As-Built Baseline Monitoring Report
FINAL VERSION
Horne Creek Tributaries Mitigation Project
Monitoring Year 0
Calendar Year of Data Collection: 2020

NCDEQ DMS Project Identification # 100026
NCDEQ DMS Contract # 7181
Yadkin River Basin (Cataloging Unit 03040101)
USACE Action ID Number: SAW-2017-01510
NCDEQ DWR Project # 2017-1156
Surry County, NC
Contracted Under RFP # 16-006993
Data Collection Period: May 2020
Submission Date: August 2020

RE: WLS Responses to NCDEQ DMS Review Comments for Task 6 Submittal, Draft Baseline Monitoring Report for the Horne Creek Tributaries Mitigation Project, DMS Full-Delivery Project ID #100026, Contract #7181, Yadkin River Basin, Cataloging Unit 03040101, Surry County, NC

FIGURE
1a

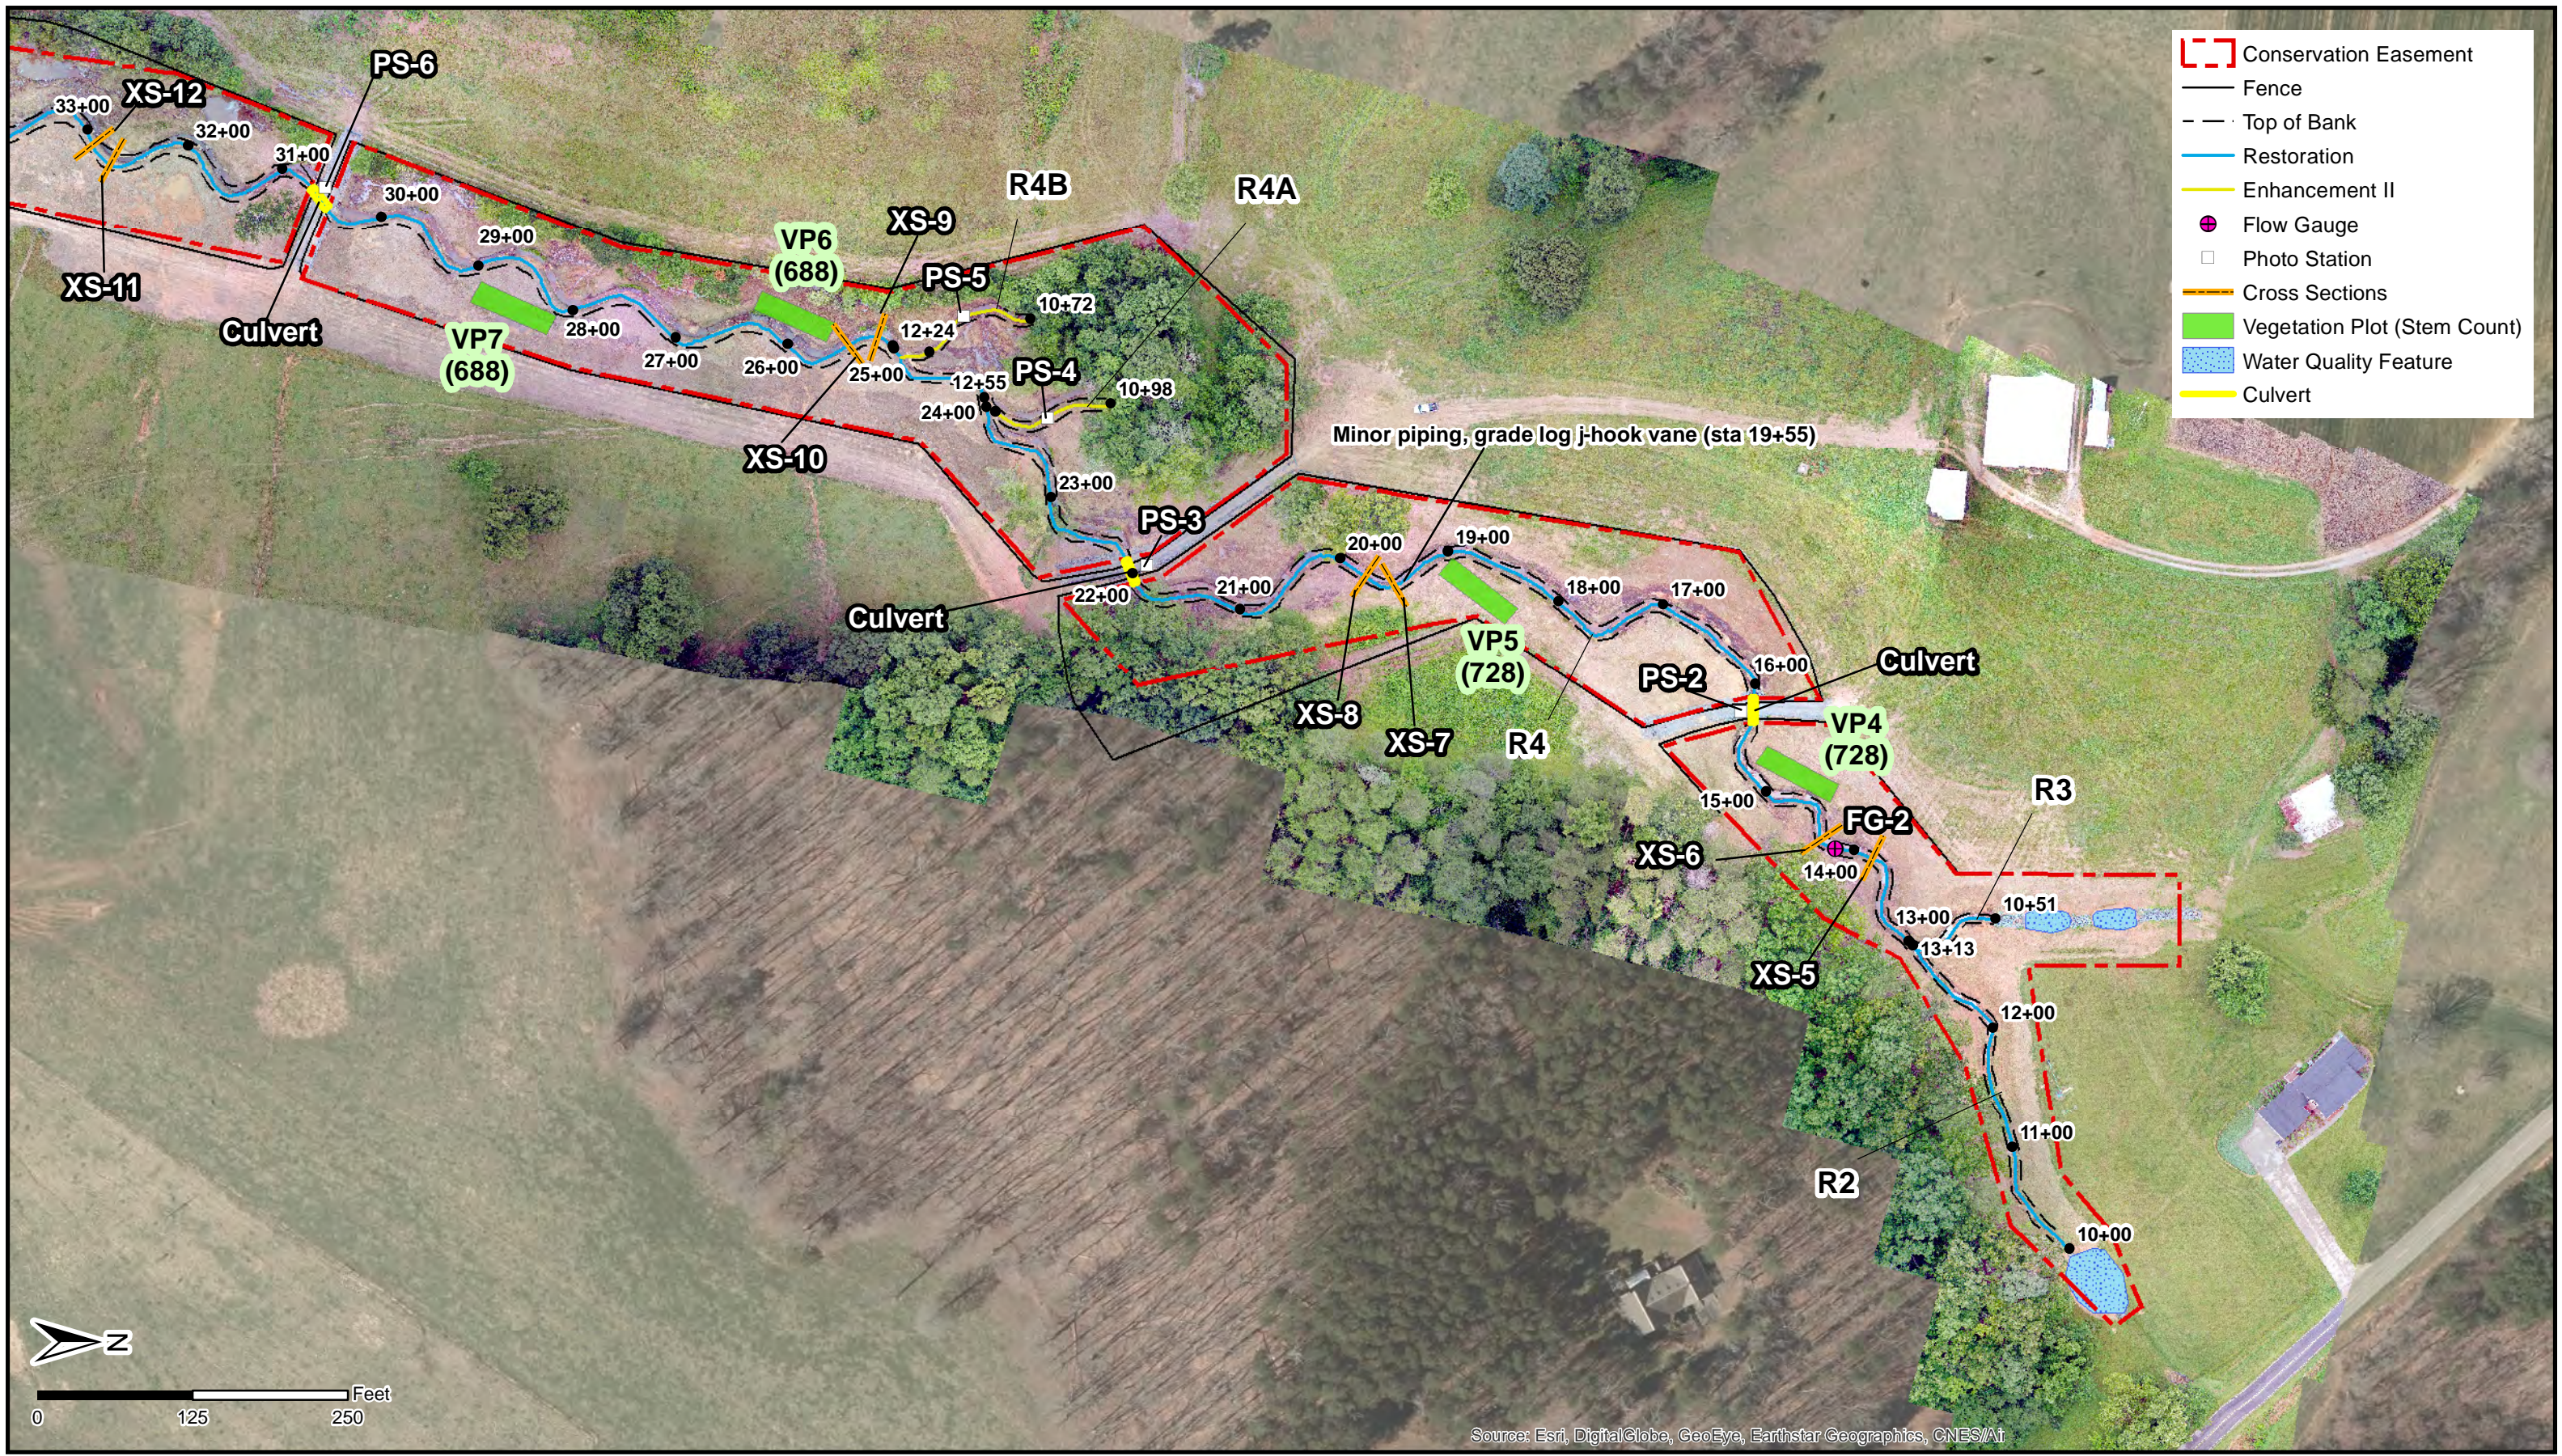
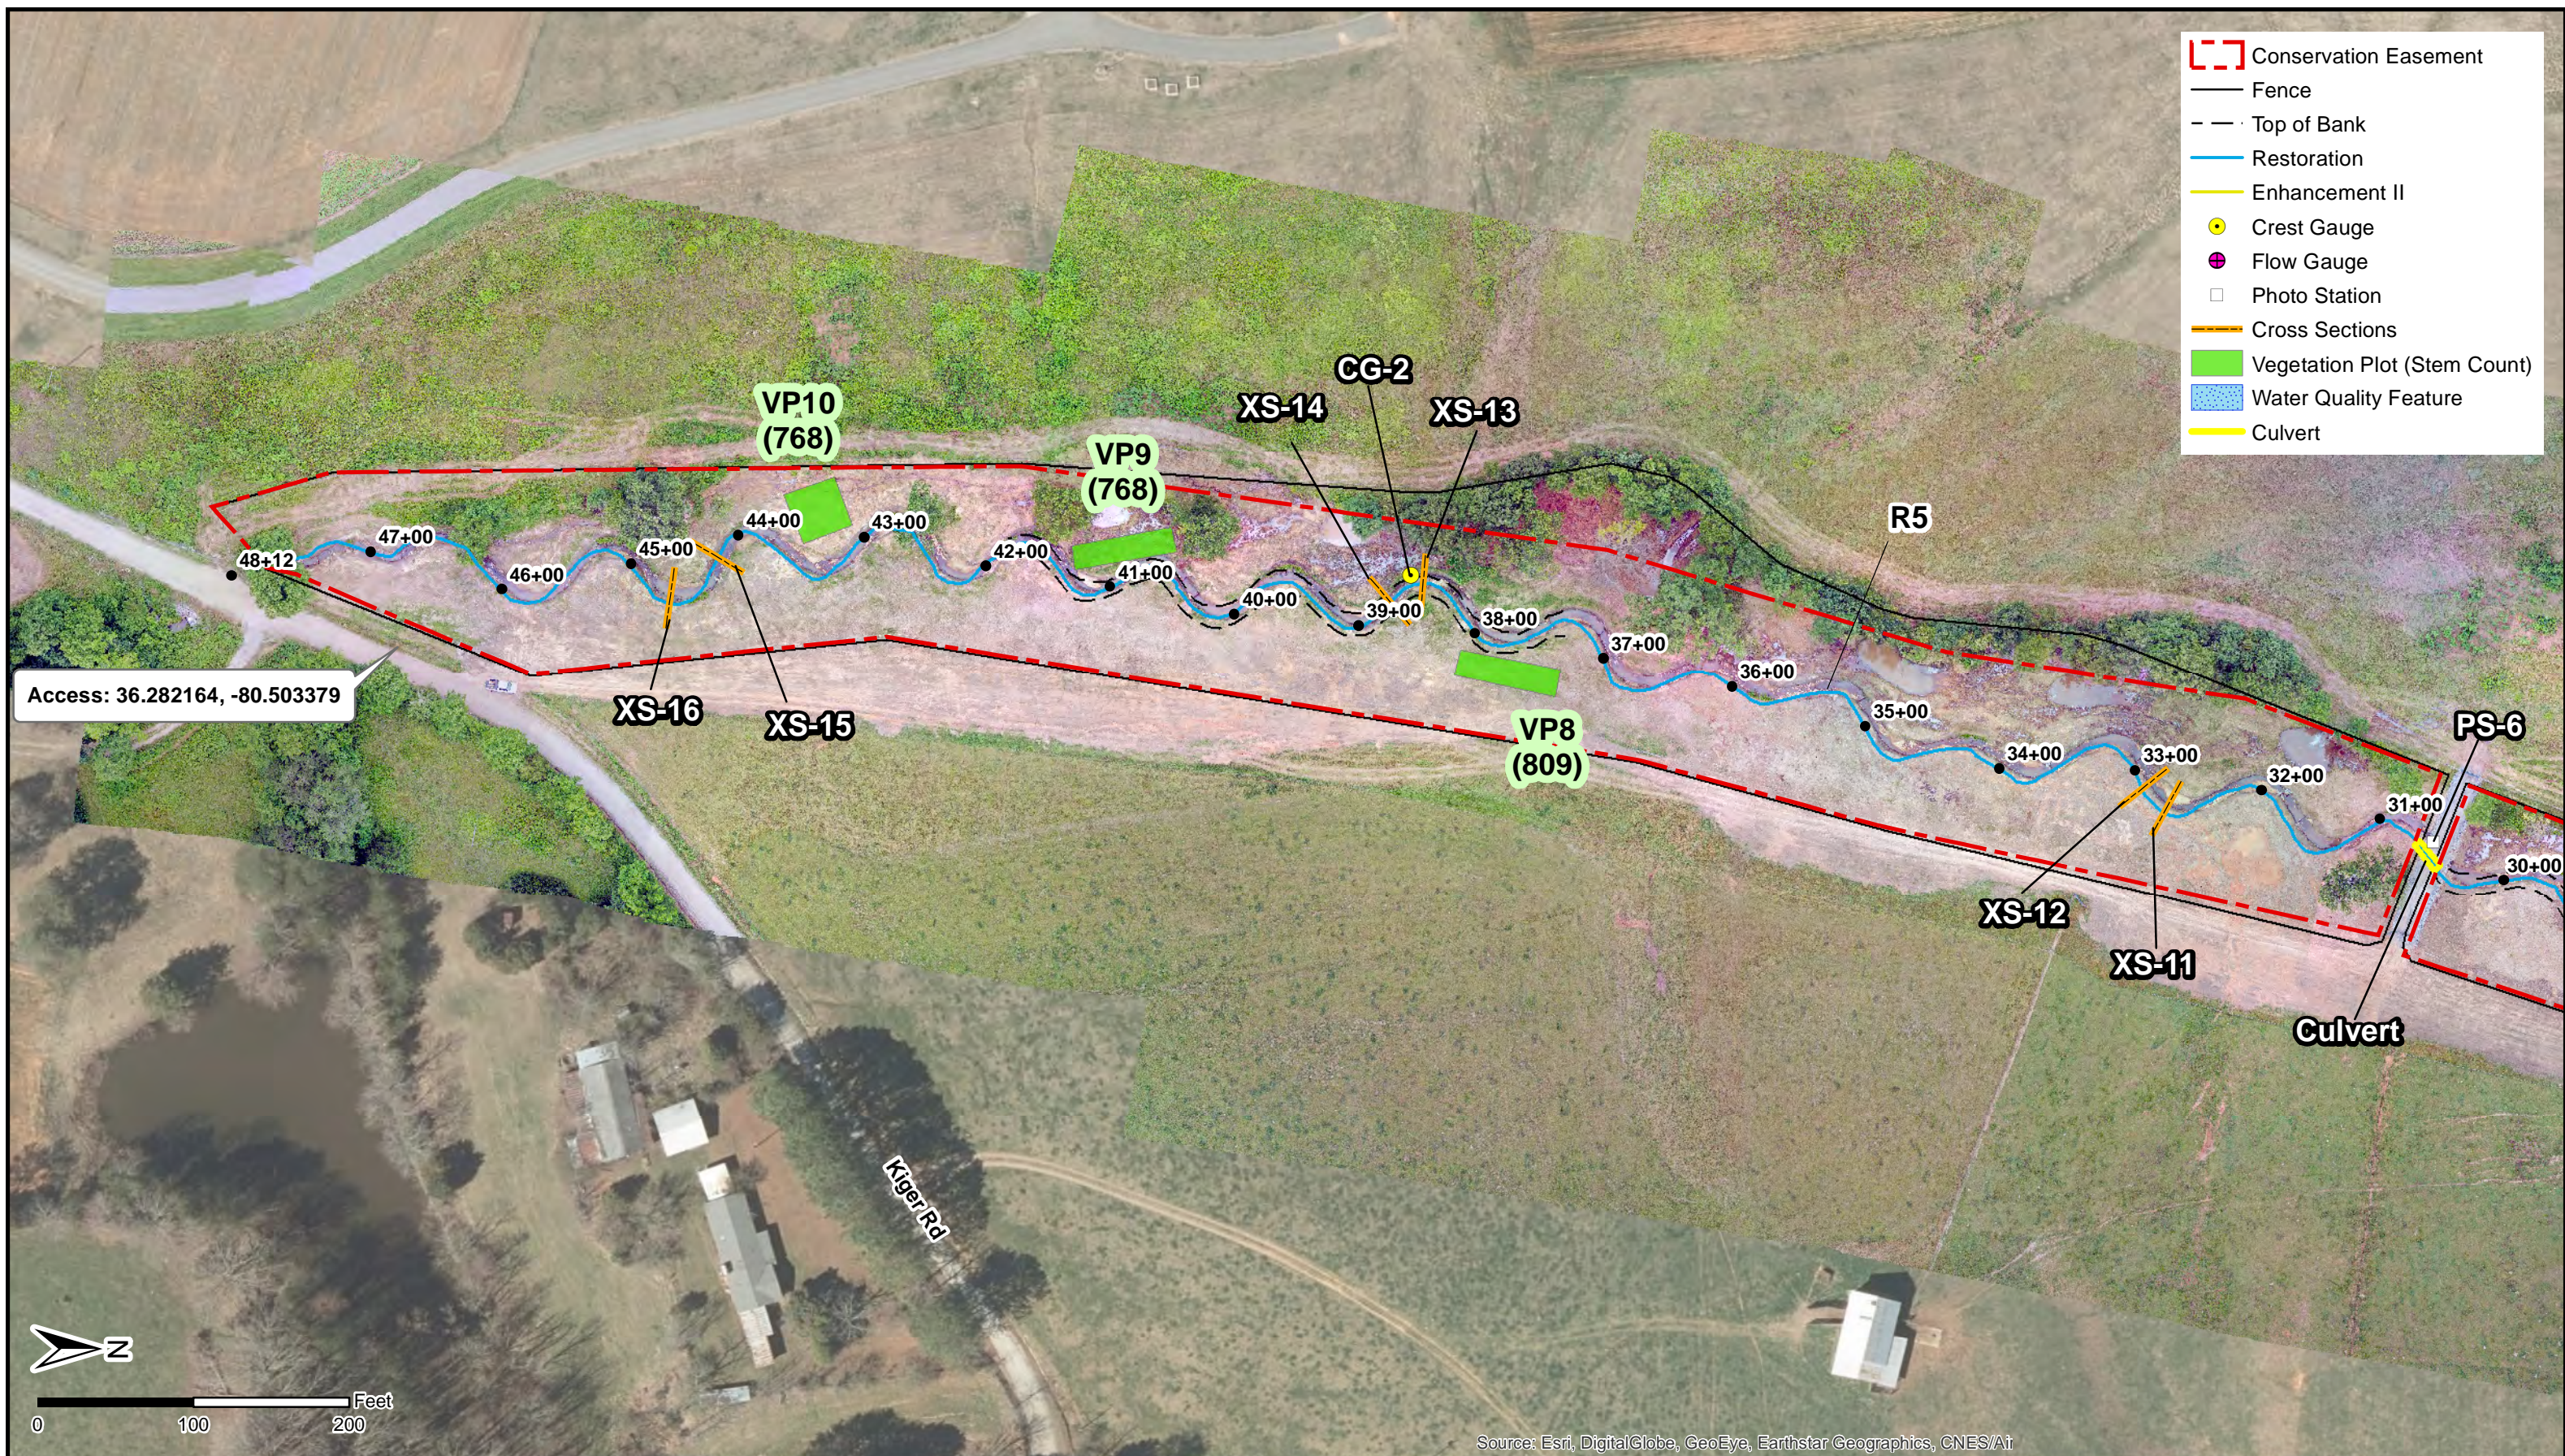
- **CCPV: Please add an overview map that shows both project streams in relation to one another.** WLS Response: An overview map displaying all project reaches was created and added to the CCPV.

- **CCPV: Please include stationing. When photo points are added in MY1, please include these locations on the CCPV.** WLS Response: Stream stationing and photo points have been added to the CCPV.

Project Name	Horne Creek Tributaries Mitigation Project
Project ID	100026
Reach ID	R1
Cross Section ID	XS-4
Field Crew	K. Obermiller, E. Dunnigan

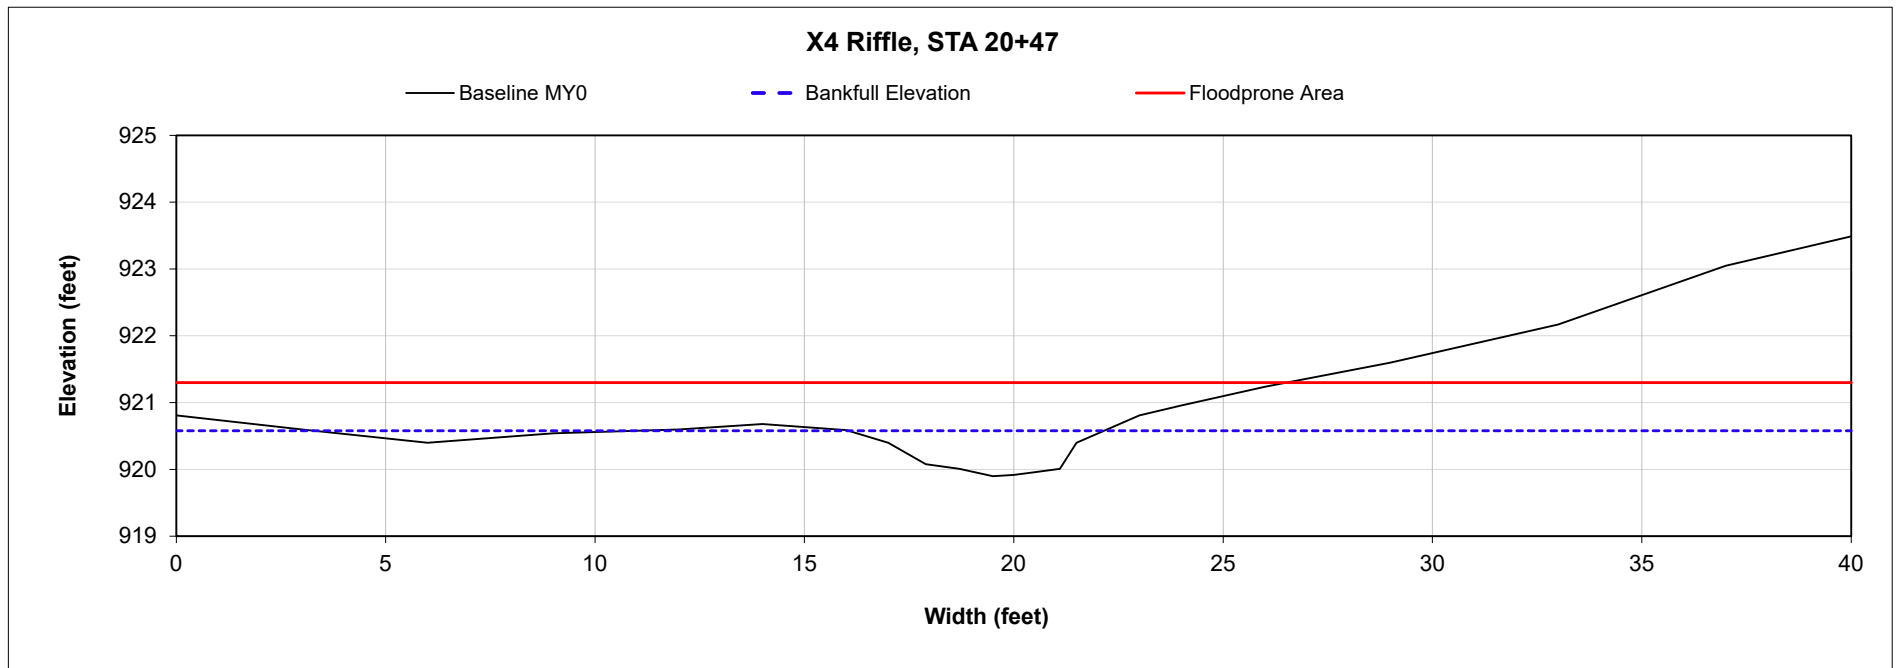
• **XS4: Is the shot near the 10' mark a rod height error? The photographs of the cross section do not seem to indicate an approximate 1.5' height difference on the left bank. Please verify.** WLS Response: The shot at the 10' mark for XS-4 was an error due to incorrectly inputting the data into the Mecklenburg spreadsheet. WLS has corrected the reading and updated the data and Appendix D accordingly.

Project Name	Horne Creek Tributaries Mitigation Project
Project ID	100026
Reach ID	R5
Cross Section ID	XS-13
Field Crew	K. Obermiller, E. Dunnigan

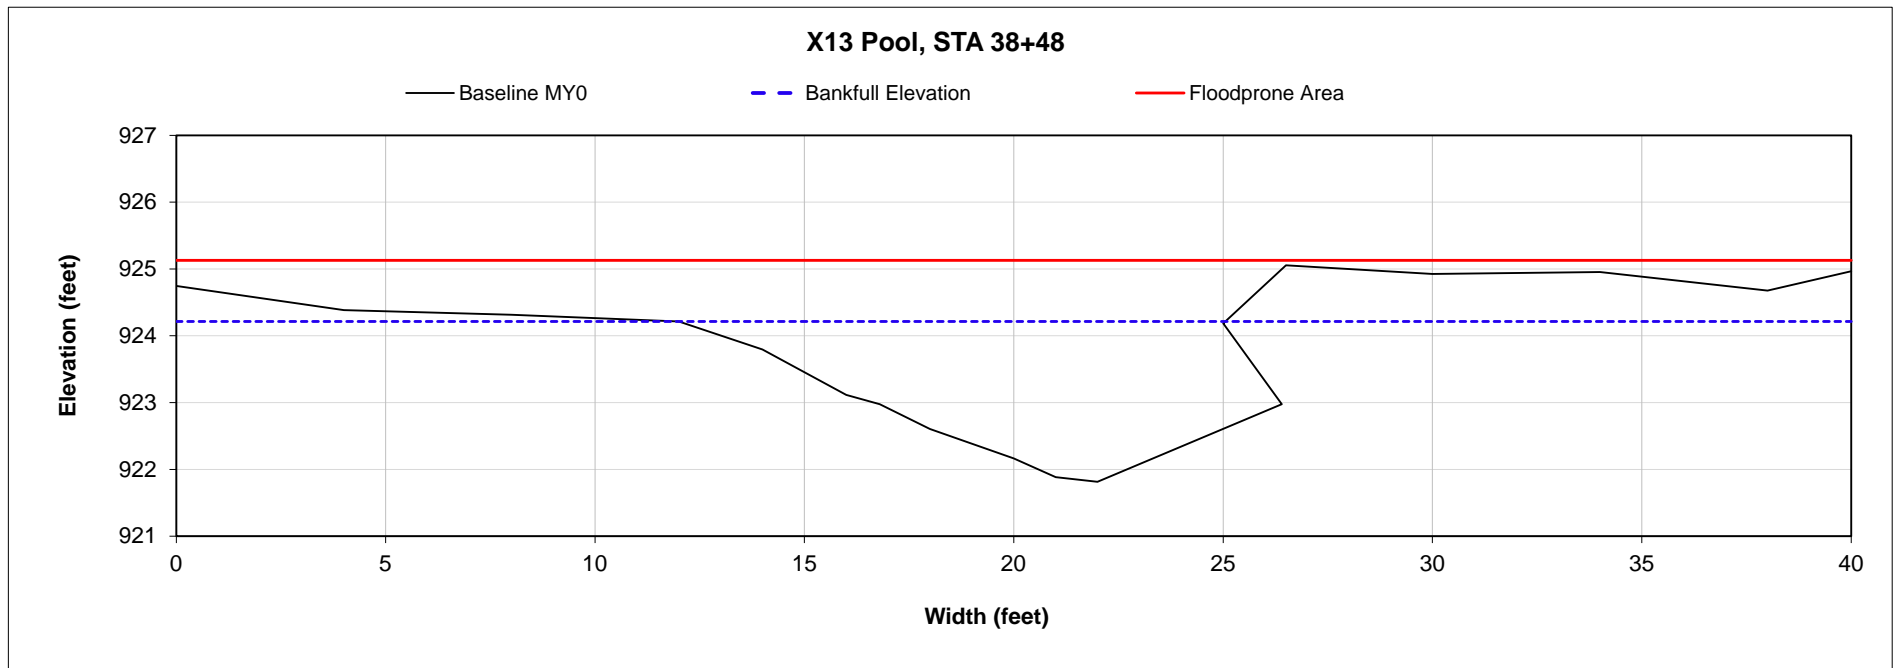
• **X13: Is the right bank shot a survey error or was an offset shot used to capture an undercut bank? The right bank photos for XS13 do not seem to correlate to the surveyed section. Please verify and correct as necessary.** WLS Response: XS-13 was shot using an offset to capture an undercut bank in the channel. The pool undercuts a large leftover root (under the matting) from a cut down tree in this pool at the cross-section location.
